South Texas Project  
Units 1 and 2  
Docket Nos. STN 50-498 and STN 50-499  
Response to NRC Comments on Relief Request RR-ENG-3-25

**Response to NRC Comments on Relief Request RR-ENG-3-25**

Figure 1.3-1 8-RH-1106-KB2, Weld 13 (Extracted from Reference DWG B-RH-7)

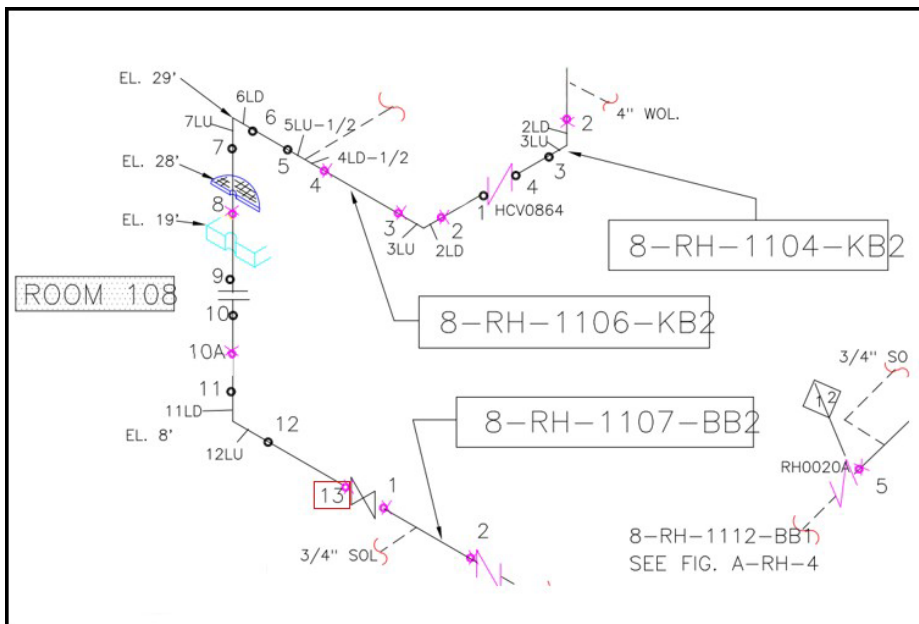
8-RH-1106-KB2, Weld 13: Identified as 8-RH-1106-KB2, Weld 13 in Attachment 1, Table 1 and as 8-RH-1006-KB2, Weld 13 in Attachment 1 Section 1.3 and possibly 8-RH-1107-BB2 in Figure 1.3-1 (The pointer to "13" is labeled 8-RH-1107-BB2 why the label 8-RH-1106-KB2 is pointing off the figure). Clarify the correct designation.

The designation in Attachment 1 Section 1.3 contains a typographical error and Figure 1.3-1 was inadvertently clipped such that the label for 8-RH-1106-KB2 was pointing off the figure. The correct designation is 8-RH-1106-KB2, Weld 13 and a revised more expansive version of Figure 1.3-1 follows:

Figure 2.5-1 8-RH-2106-KB2, Weld 13 (Extracted from Reference DWG B-RH-7)

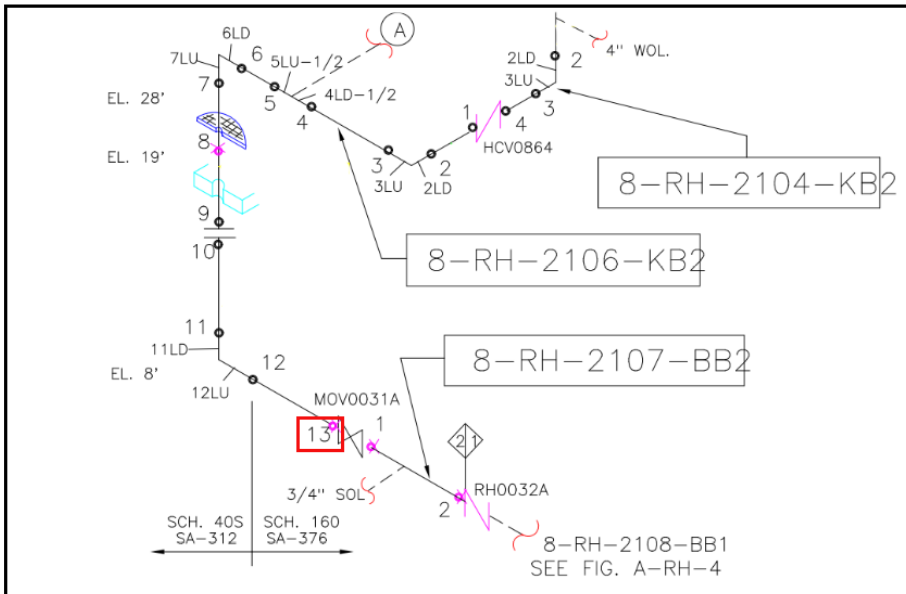
8-RH-2106-KB2, Weld 13: Identified as 8-RH-2106-KB2, Weld 13 in Attachment 1, Table 1 and as 8-RH-2106-BB2, Weld 13 in Attachment 1 Section 2.5 and as 8-RH-2107-BB2 in Attachment 1, Figure 2.5-1. Clarify the correct designation.

The designation in Attachment 1 Section 2.5 contains a typographical error and Figure 2.5-1 was inadvertently clipped such that the label for line 8-RH-2106-KB2 was not visible. The correct designation is 8-RH-2106-KB2, Weld 13 and a revised more expansive version of Figure 2.5-1 follows:
